BCA ASSESSMENT REPORT

Liverpool Civic Place – Stage 2

Project Number: 118321

Revision: Rev 2

Figure 1 – Lower Ground Level Fire Compartmentation

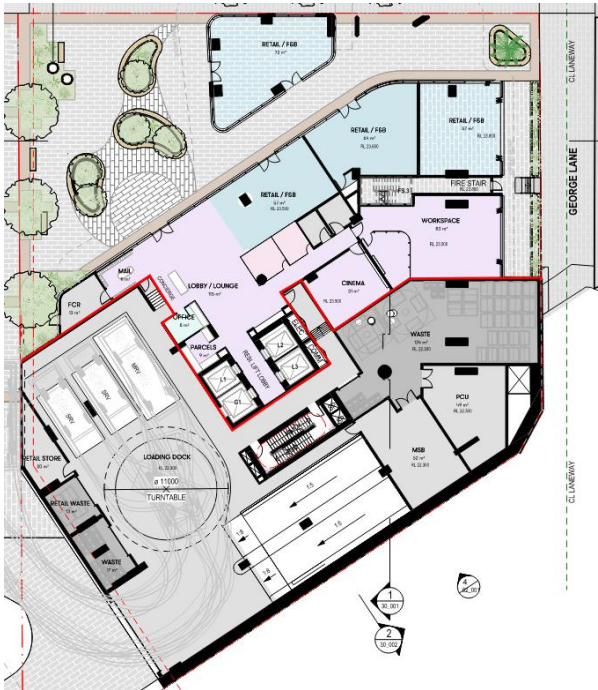
- 1. Basement Levels 1, 2, 3 and Lower Ground are assumed to form a single fire compartment due to the interconnectivity of the vehicular ramp. It is assumed that the Lower Ground Lobby and mixed use area is provided with 120min fire rated separation as illustrated below. Retail and residential half of the Lower Ground and Upper Ground Level are assumed to form the same fire compartment due to the interconnection of skylights.
